PROJECT: GILMORE AND FORT APACHE (GILMORE CREEK)
PROJECT IN CLARK COUNTY FOR CLU CONCURRENCE

SUBMITTAL: 1 ST

CITY OF LAS VEGAS		DATE:
INTER-OFFICE MEMORANDUM		November 14, 2013
TO: Land Development Services Department of Building & Safety		FROM: Albert Sung, P.E. Flood Control Project Engineer Department of Public Works
SUBJECT: Drainage Study for:		COPIES TO:
Gilmore and Fort Apache (Gilmore Creek) (Project in Clark County for CLV Concurrence)		Thomason Consulting Engineers
Cross Streets:	SWC of Fort Apache Road & Gilmore Ave.	D.R. Horton
File Number:	F:\Depot\DSMemos\DS4635A.doc	Bart Anderson, P.E., DevCo
Parcel Number:	138-07-602-002	CCPW
Zoning Action:	ANX-51432	
FEMA Flood Zone	YES NO X	
Proposed Storm Drain	YES NO X

SHEET
C-10
10 OF 26 SHEETS
CLV DRAWING NO.
630.98

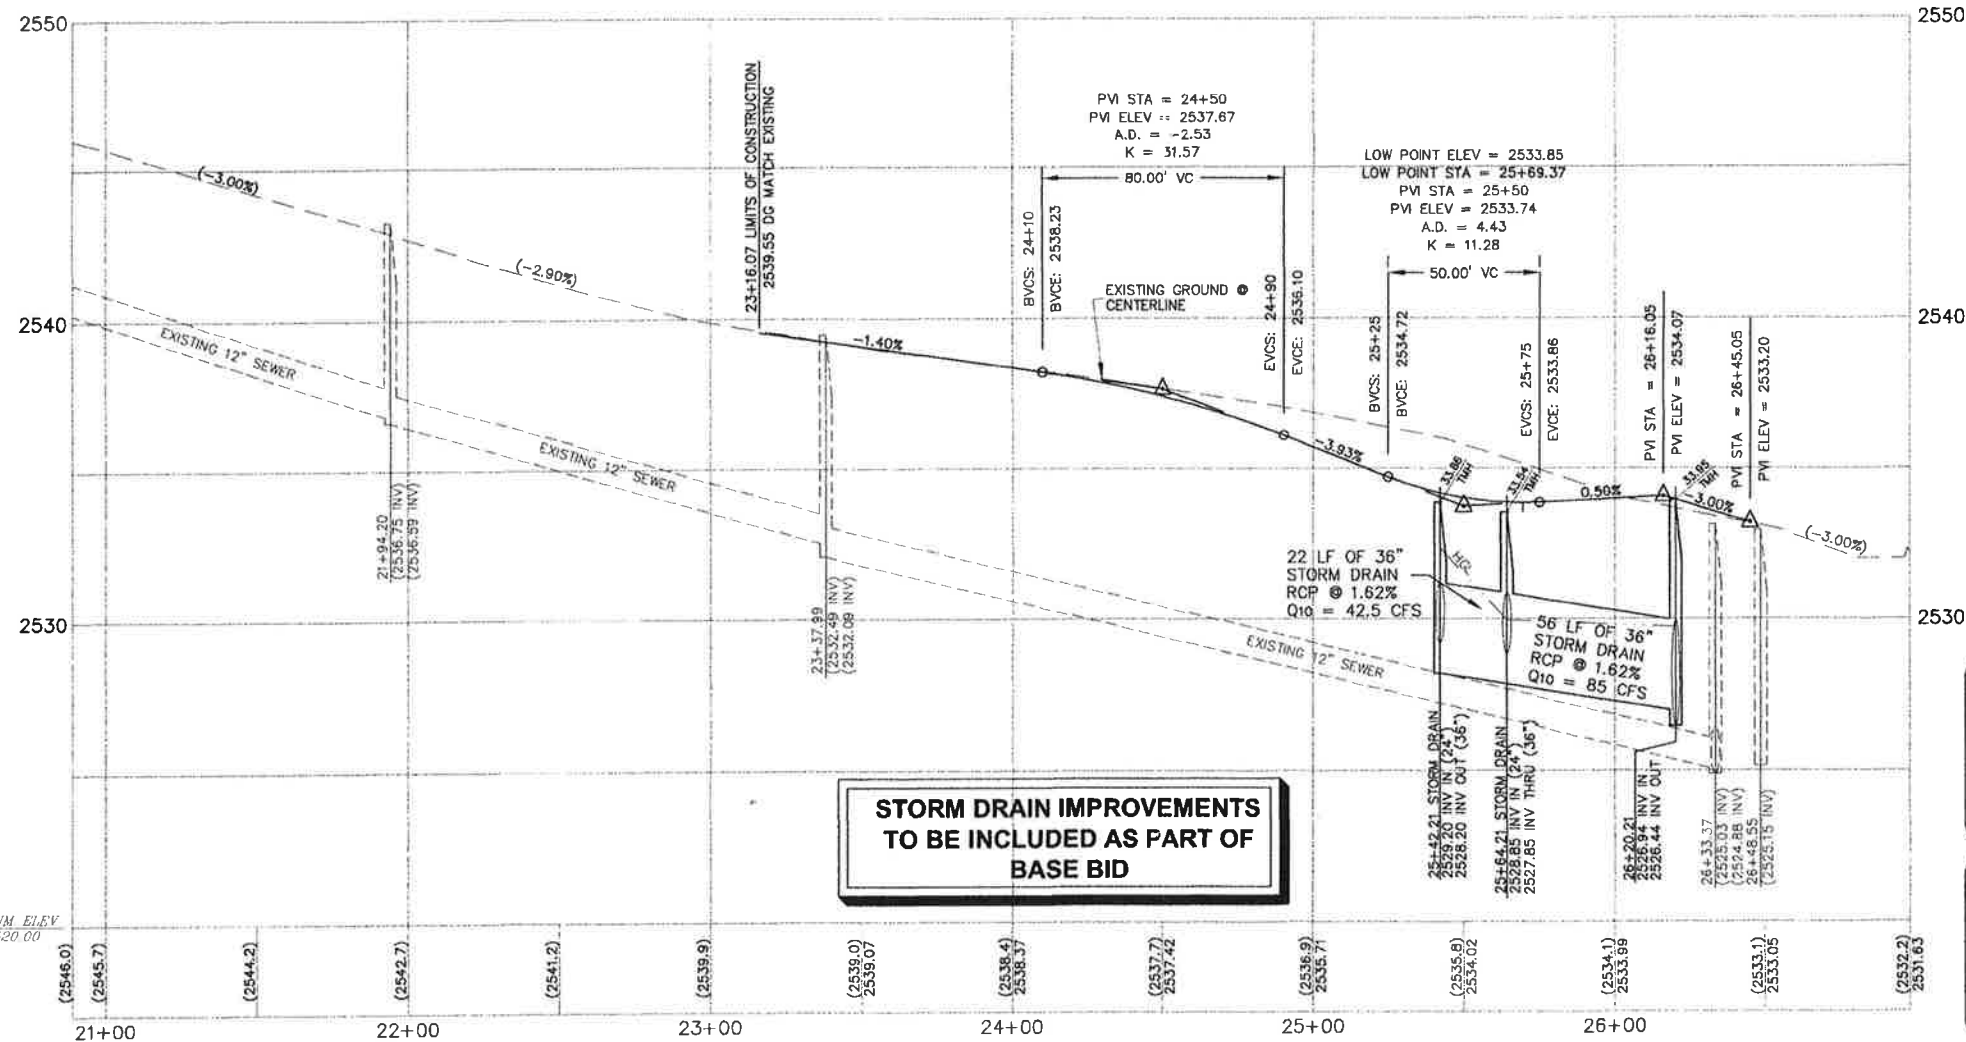
2. Provide existing contours on the grading plans in the next submittal so as to determine the extent of proposed cut and fill by the developments.
3. Revise the callout of the *City of Las Vegas* recorded construction drawing number for an existing storm drain from "107Y-4214-5F" to "**630.98**".
